SERVICE BULLETIN

PURPOSE : CORRECTION	ISSUE NO. : MSB-14EXL21-501	DATE : 2014-12-15
SUBJECT : Error in writing about the clutch switch		<DESTINATION/MODEL> (As per attached sheet 1) <M/Y> 09-15
GROUP : Gr:21(Clutch)

L200/ TRITON /SPORTERO/STRADA/ STRADA SPORTERO

AC900934AB

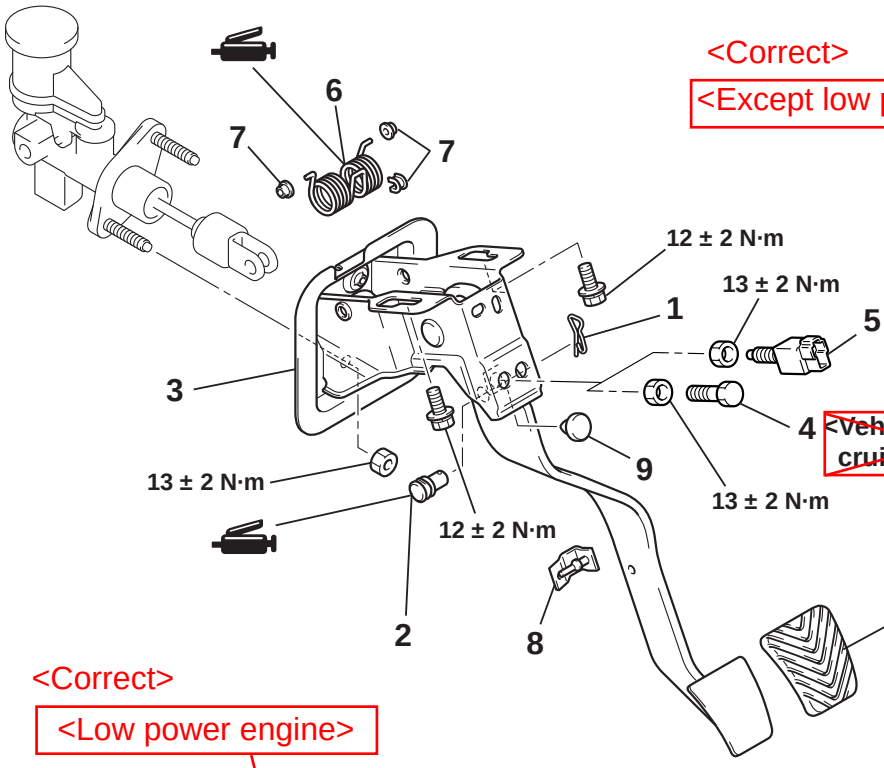
<Correct>
<Except low power engine>
<Incorrect>
<Vehicles with cruise control>
<Vehicles without cruise control>
<Correct>
<Low power engine>

1. Snap pin
2. Clevis pin
3. Clutch pedal assembly
4. Adjusting bolt <Vehicles without cruise control> <Incorrect>
>>A<< 5. Clutch switch <Vehicles with cruise control> <Incorrect>

<Correct>
<Low power engine>

<Incorrect>

<Correct> <Except low power engine>

AC511496AC

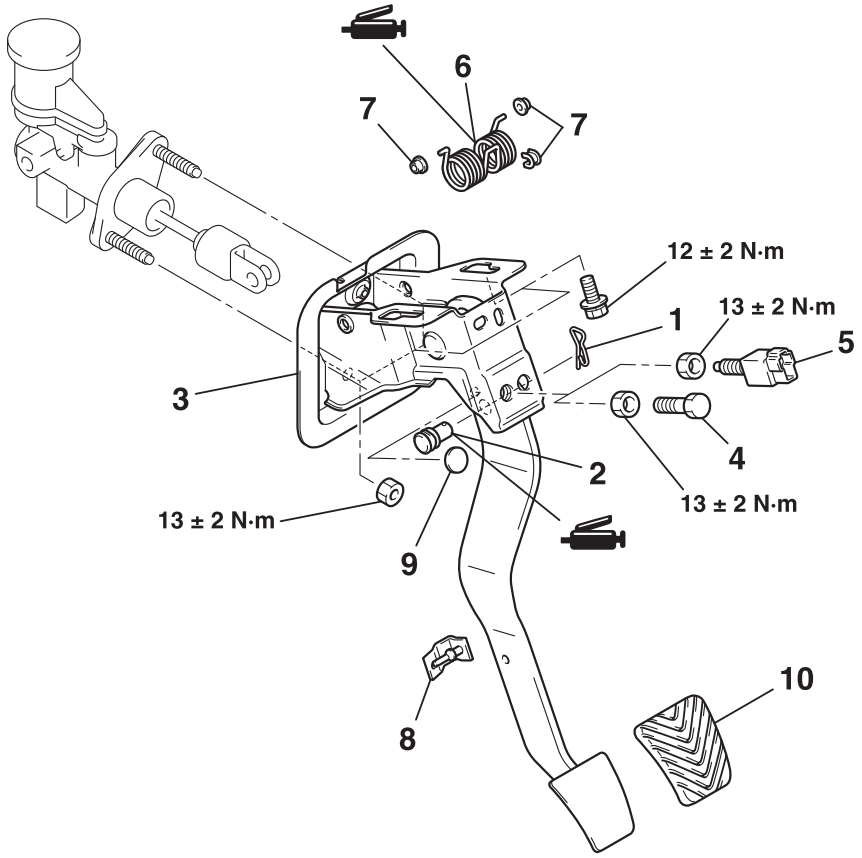
1. Snap pin
2. Clevis pin
3. Clutch pedal assembly
4. Adjusting bolt <Vehicles without cruise control>
>>A<<Ia 5. Clutch switch <Vehicles with cruise control>

<Added>
Except 6G7,
6G7, <Added>

6G7, <Added>

Attached sheet 4

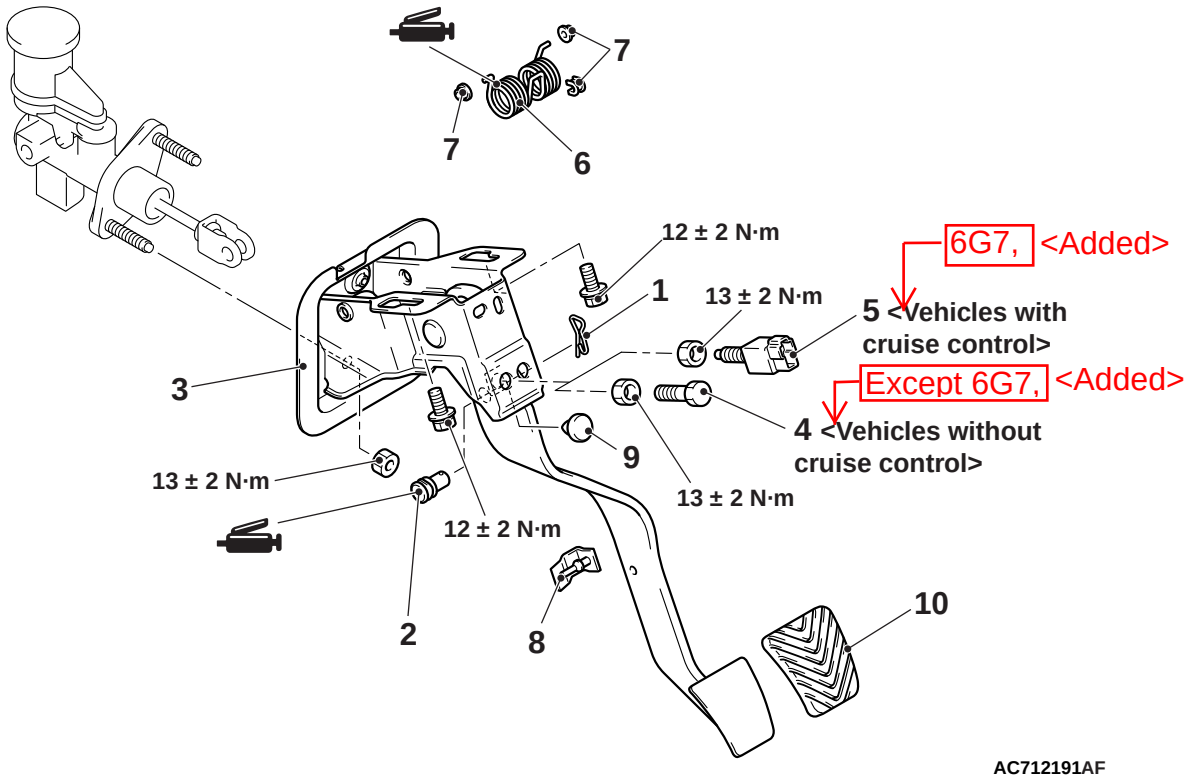
1. Snap pin
2. Clevis pin
3. Clutch pedal assembly
4. Adjusting bolt <Vehicles without cruise control> <Added> Except 6G7,
>>A<< 5. Clutch switch <Vehicles with cruise control> 6G7, <Added>

>>A<< CLUTCH SWITCH <VEHICLES WITH CRUISE CONTROL> 6G7, <Added>
